**SUBDIVISION &
ZONING AMENDMENT STAFF REPORT****Date: May 19, 2016****APPLICANT NAME**

Thames Addition to Theodore Subdivision, Resubdivision of Lot 8

LOCATION5550, 5560, 5580 and 5590 Peary Road
(Southeast corner of Cary Hamilton Road and Peary Road).**CITY COUNCIL
DISTRICT**

SITE PLAN

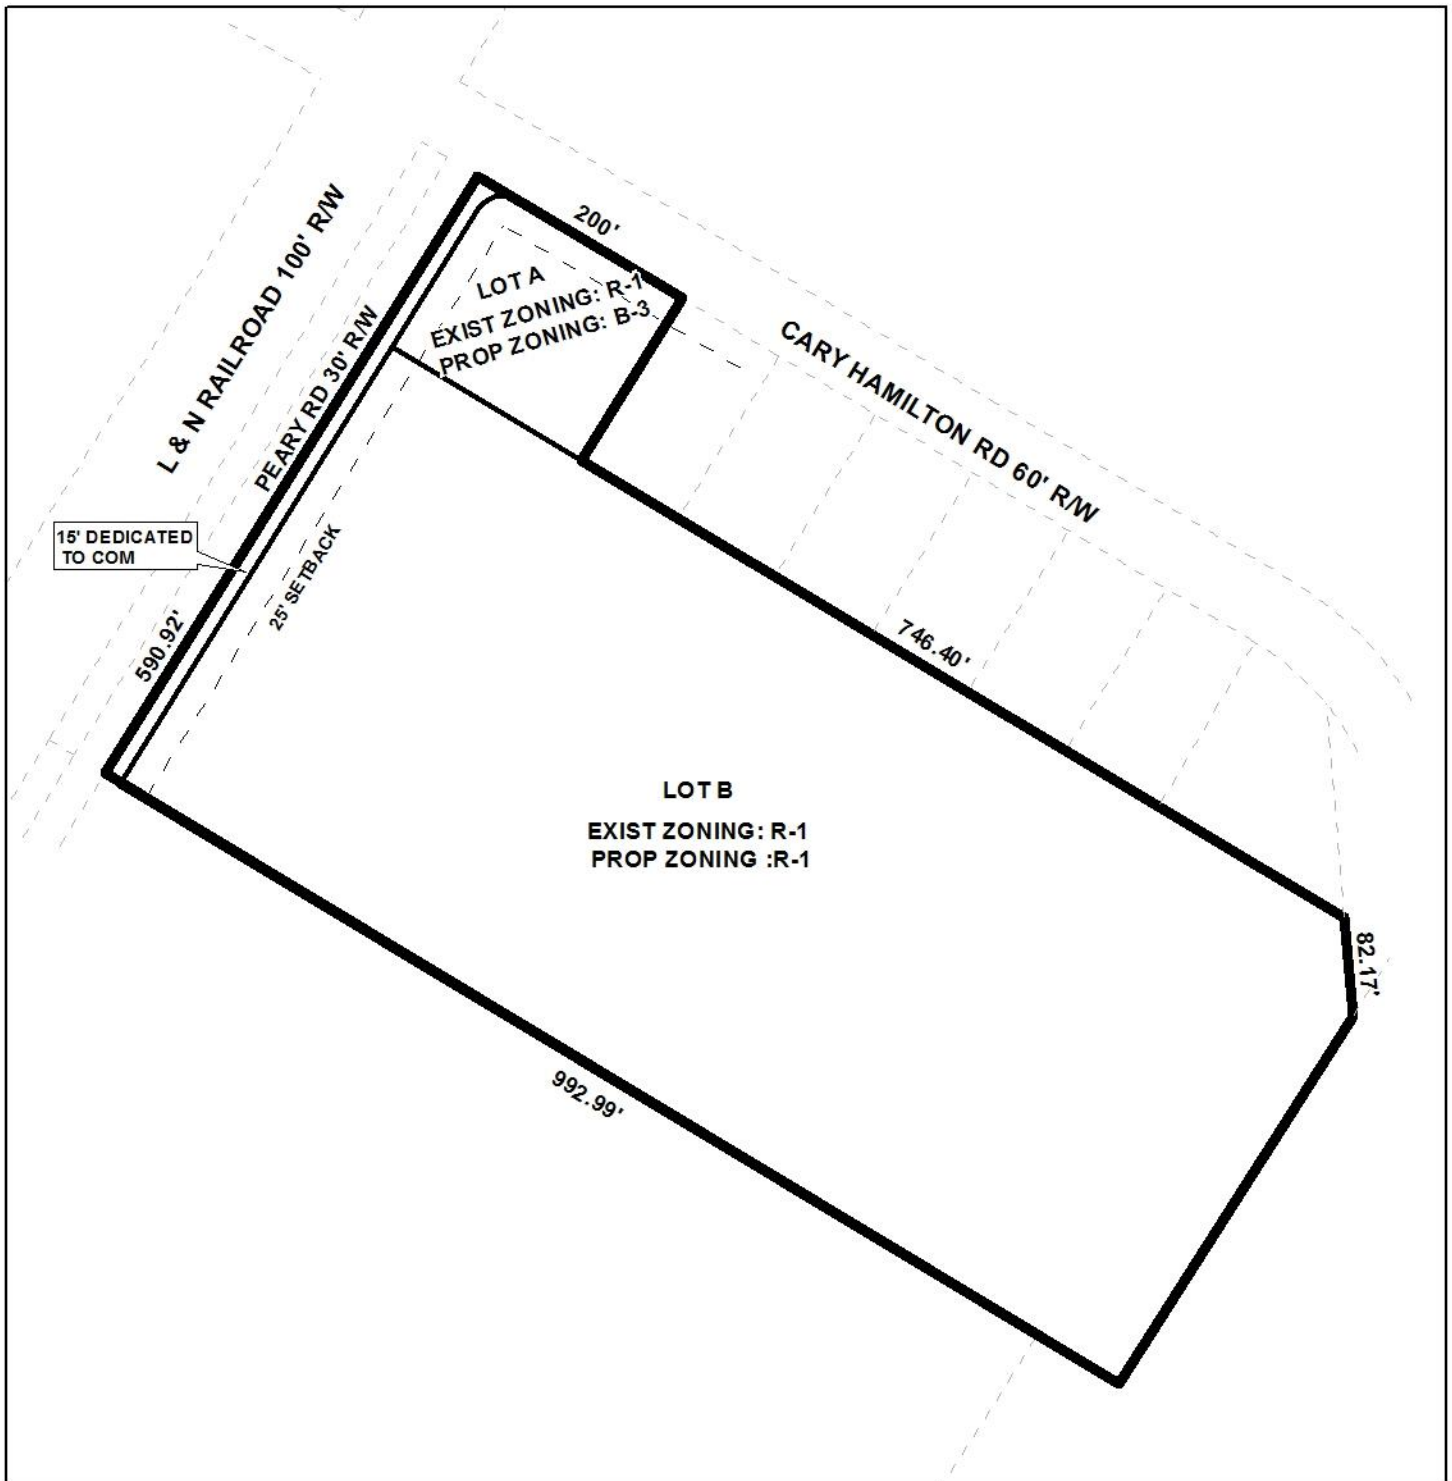
The site plan provided illustrates the proposed 1,000 square-foot office building and a 1,250 square-foot maintenance garage; however, as there are two structures proposed on the site, a Planned Unit Development application should have been submitted to allow the two buildings on a single building site. No dumpster is indicated nor is any buffering along the Southern edge of the site adjacent to R-1 zoning. There is no public sidewalk indicated along the street frontages. Compliant parking, access and maneuvering is indicated. The site plan does account for dedications required for the Subdivision.
